MCA response to U.S. Comments

Comments of Flash Airlines upon draft final report into the loss of Flash Airlines Flight 604

Figure 2.5.13.16a Scenario 10a - F/O wheel jam (longitudinal parameters)

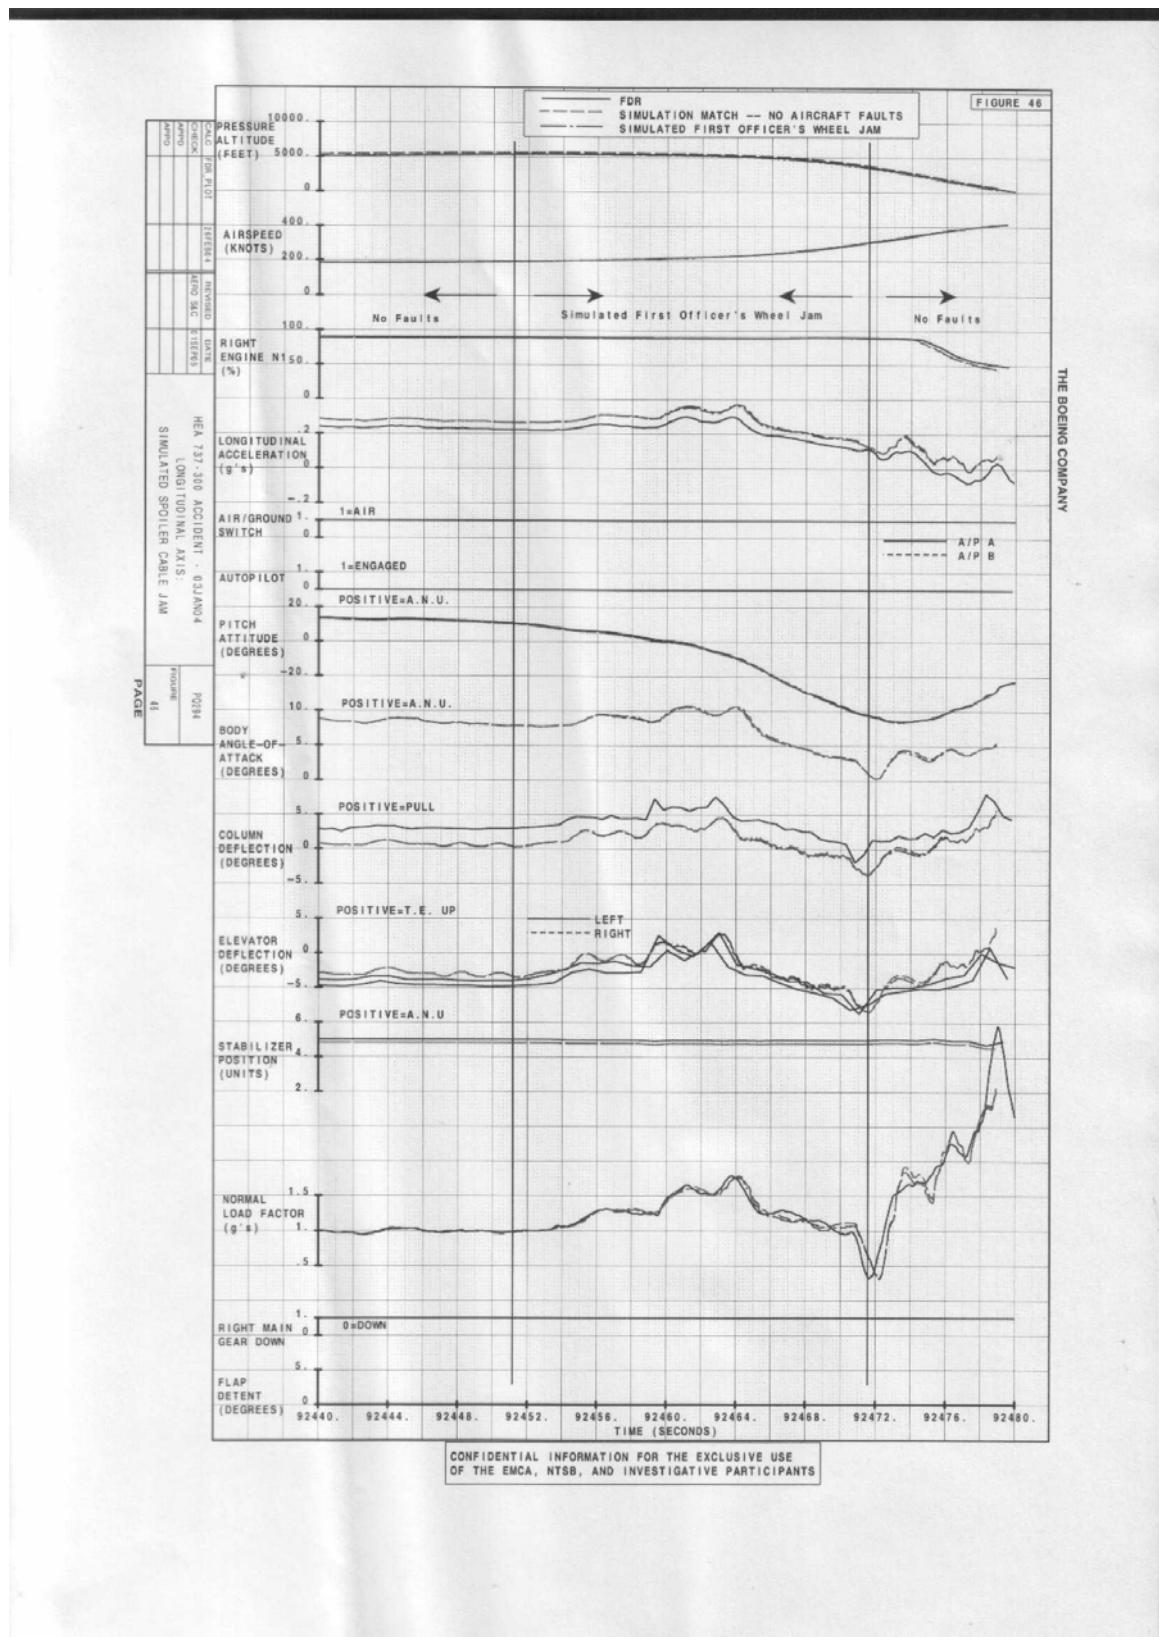
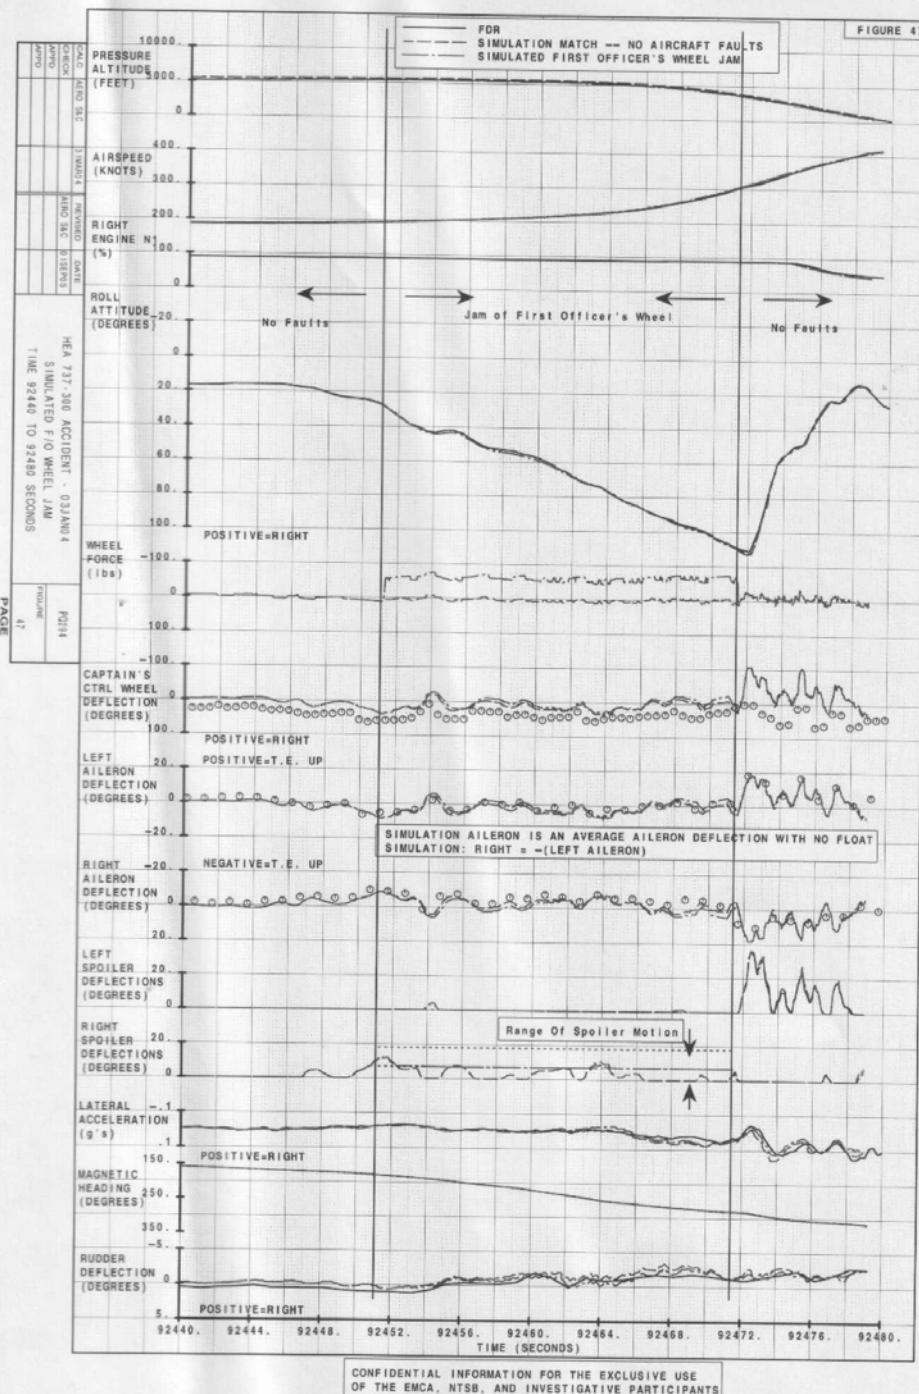
The MCA subsequently proposed two additional hypothetical failure scenarios: a temporary spoiler wing cable jam and a temporary first officer control wheel jam. The MCA's draft final report properly concluded that the accident airplane's motion is defined by FDR- recorded control surface deflections, including spoiler and aileron (control wheel) deflections. The effects of a temporary spoiler wing cable jam or of a temporary first officer control wheel jam would render the previous statement (and the simulation data analyses upon which it is based) false. Therefore, considering these hypothetical failure scenarios is illogical.

Further, the MCA's draft final report did not explain how the airplane got to the point in the right roll at which the temporary jams supposedly occurred. Initially, the airplane was in a left bank, but it then started banking right. The MCA proposes that the fault occurred as the airplane was increasing through a bank angle of about 25°; however, the airplane's initial departure from the 20°-left-bank attitude occurred about 45 seconds before the hypothetical faults would have started. In addition, the first officer's comment, "turning right, sir," occurred about 9 seconds before the hypothetical faults would have started.

As shown from the two plots, the results obtained from the M-Cab test show a very close consistency with the FDR data which may explain this event. The estimated aileron wheel forces needed to move the wheel to correct for the right turn tendency is ~ 50 lbs.

In response to the comment *"The MCA's draft final report properly concluded that the accident airplane's motion is defined by FDR- recorded control surface deflections, including spoiler and aileron (control wheel) deflections. The effects of a temporary spoiler wing cable jam or of a temporary first officer control wheel jam would render the previous statement (and the simulation data analyses upon which it is based) false"*, the statement is incorrect due to the close consistency showed in above..
